Certified Action

of the City of Raleigh Planning Commission

Case File / Name: GH-5-12 / Crabtree Commons

Nature of Case: This request is to approve 335 units within a 6 building group housing development on 7.11 acres (2 parcels) zoned Shopping Center CUD with Pedestrian Business Overlay District (PBOD).

GH-5-12 Crabtree Commons - Site Plan

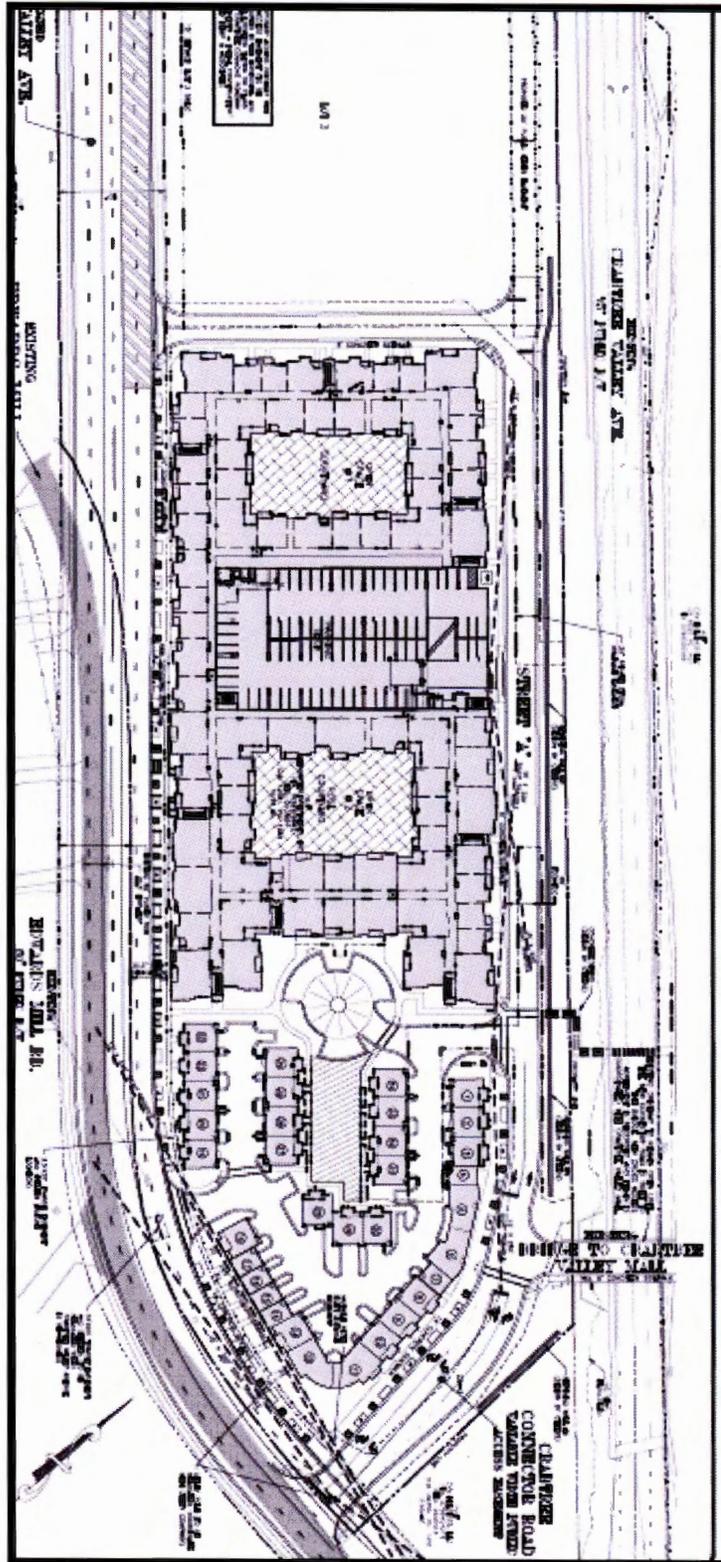
<u>Comment</u>	<u>Response</u>
Reducing the retaining wall to 6-7 feet and planting trailing plants at the top of the wall	Retaining wall is reduced to 7 feet with Trumpet Vine installed at the top of the wall
Adding vegetation and green space to the "condo" side of the project. Add trees in the alley area of project. A lack of open space for everyday activities	The condominium side of the project has been revised to create a large expanse of open space has been created. River Birches have been added on the alley side of the condominiums
Move the paving detail to the alley intersection to indicate that the alleys are pedestrian space or removing it all-together	The site has been revised so that the intersection described in the comment no longer exists
The parking deck is insufficiently screened. Because it's monolithic it is reading as "too important." The deck needs to be broken down into smaller vertical modules to be integrated into the remainder of the project. Because of the lack of screening, it does not appear that the deck meets code section 10-2051(d)(1)(c)(3) regarding parking screening in PBODs to meeto their density requirement	The elevation of the garage has been redesigned to provide a façade consistent with the apartment buildings.

Don't use lagustrum as it is considered semi -invasive. Consider evergreens such as camellias instead.	Lagustrum has been removed from the plant list and replaced with camellias.
